**1 Products affected**

**2 Type of change**

Product Change Notification					2573 Change of marking		
owner	creation date	release date	released by	change order no	rev	page	D10-055-680
zeierjo	31.03.2021	31.03.2021	muehlema	2021025	B	1 of 2

Old product rating and approval	New product rating and approval
<p>Terminals in orientation A</p> <p>Front side</p>  <p>Back side</p> 	<p>Terminals in orientation A</p> <p>Front side</p>  <p>Back side</p>

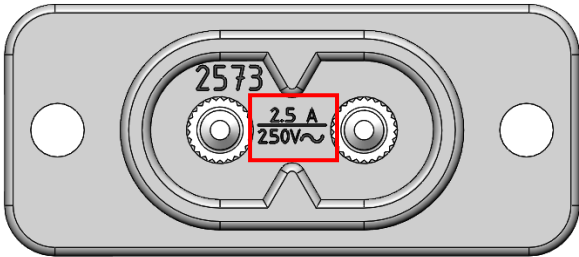
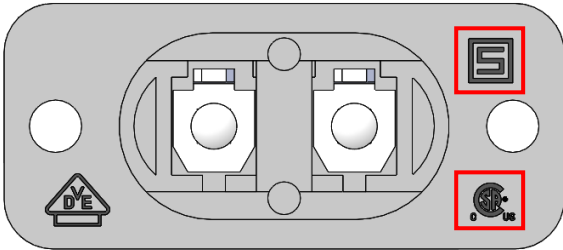
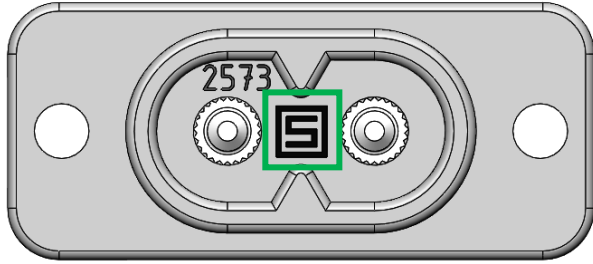
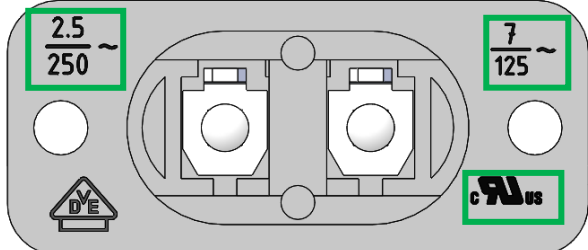
UL upgrade from UL 498 to UL 60320-1.

Marking for UL rating 7A/125V~ added. Marking for IEC rating 2.5A/250V~ updated. CSA / UR Approval Mark replaced by cURus.
